Applicant: Airbus U.S. Manufacturing Facility
Greg.Rensink@airbus.com
Form 442 File Number: 1684-EX-CN-2023
Form 442 Confirmation Number: EL265365
Correspondence Reference Number: 82022
Date of Original Email: 11/29/2023

Thank you for your reply. See below in response to your request for more information, **1) thru 6)**.

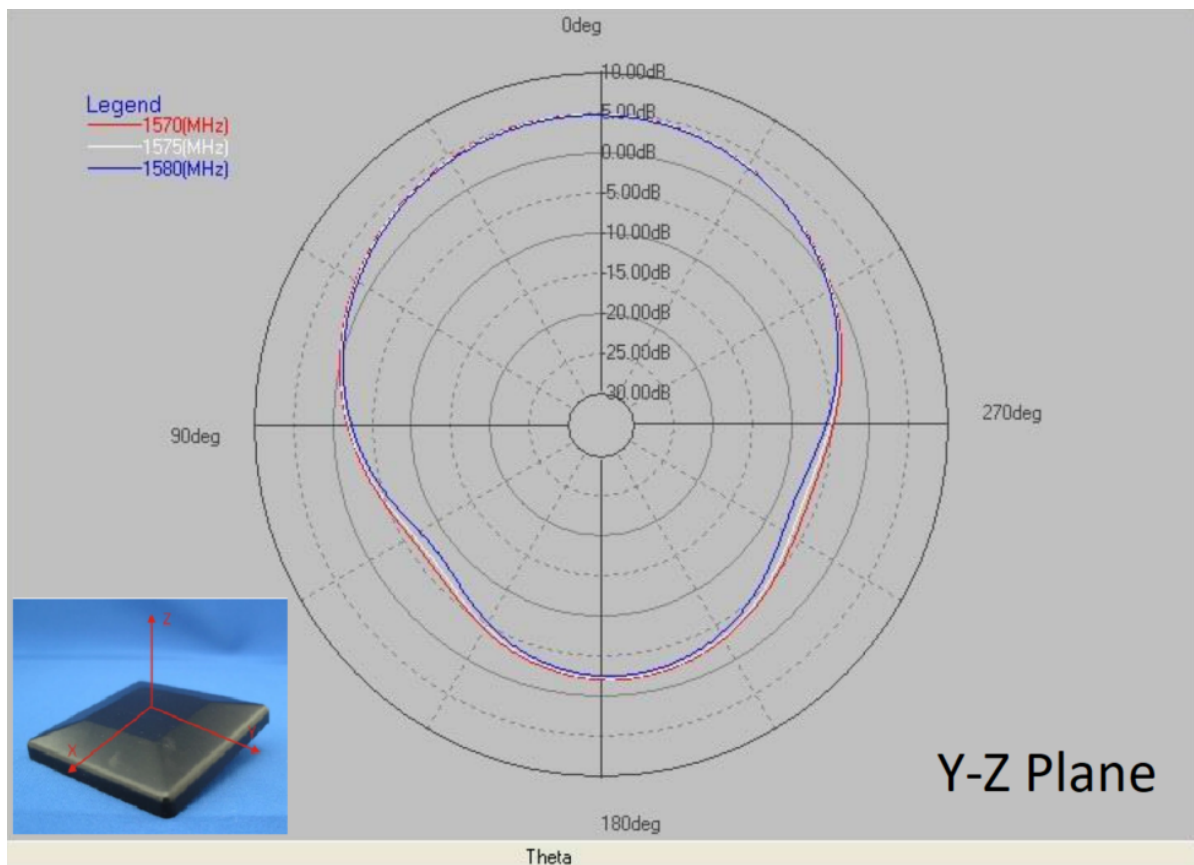
1) Could you please explain why you used d = 55 meters in your calculation?

For the re-radiating antenna, the amplitude and radiation pattern of the signal depends on what direction the antenna is mounted. The strongest signal is +5.00 dB in the 0deg +Z plane, which is why they are pointed at the nose of the two aircraft. The signal strength decreases towards the edge of the antenna and becomes attenuated behind the antenna. See below hemispheric radiation patterns in the X-Z Plane and Y-Z Plane, outward from the flat base.

Indeed, the nearest exterior wall is behind the antenna (d = 23m), but in this direction the signal has < 0.00 dB of gain from the antenna. Therefore, Airbus considered the worst case scenario as the shortest distance from the antenna to the exterior wall in the direction of amplified radiation (d = 55m).

X-Z Plane: Antenna Gain <0.00 dB behind the antenna

Y-Z Plane: Antenna Gain <0.00 dB behind the antenna

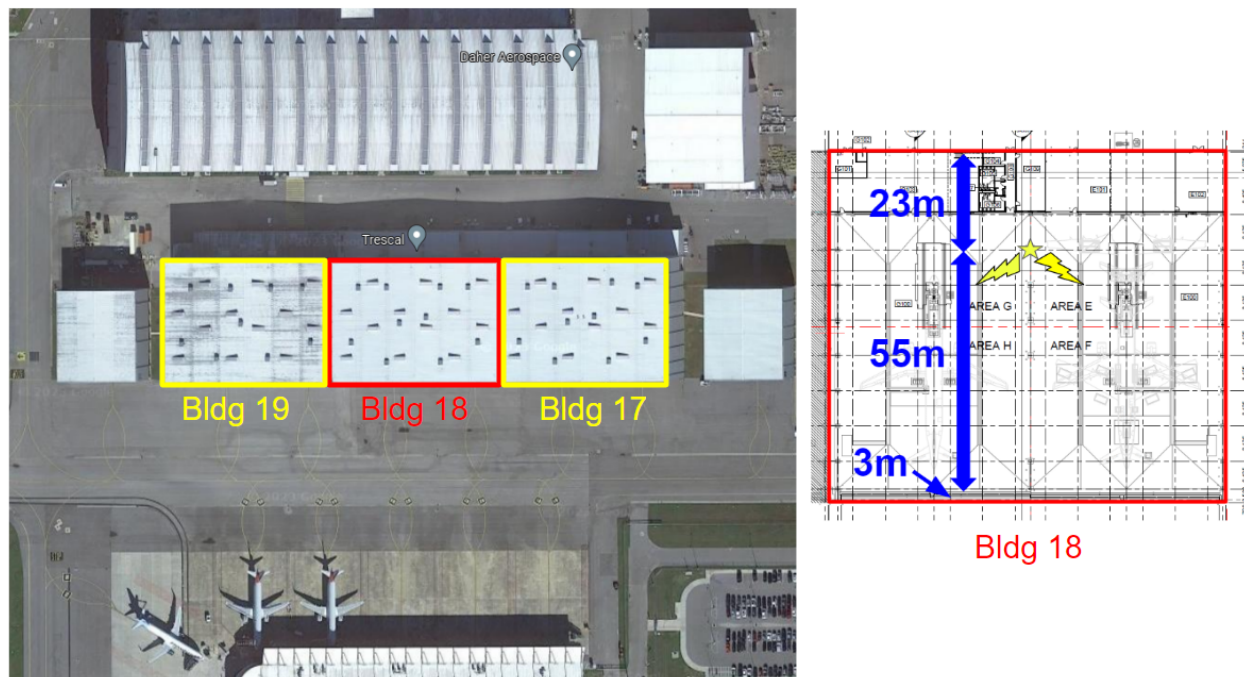
3) From the drawing that you provided it doesn't appear that this will be installed in the dead center of your facility. So your distance d should be even less than 40.5 m.

Indeed, the nearest exterior wall is behind the antenna at $d = 23\text{m}$. The further exterior wall is at $d = 55\text{m}$, and there is an additional 3m not taken into account due to overlapping hangar doors. The total building depth is $23\text{m} + 55\text{m} + 3\text{m} = 81\text{m}$. In addition, the other side of the nearest exterior wall is a corridor between Airbus buildings for industrial vehicles and pedestrians. The further exterior wall faces Airbus flight line operations.
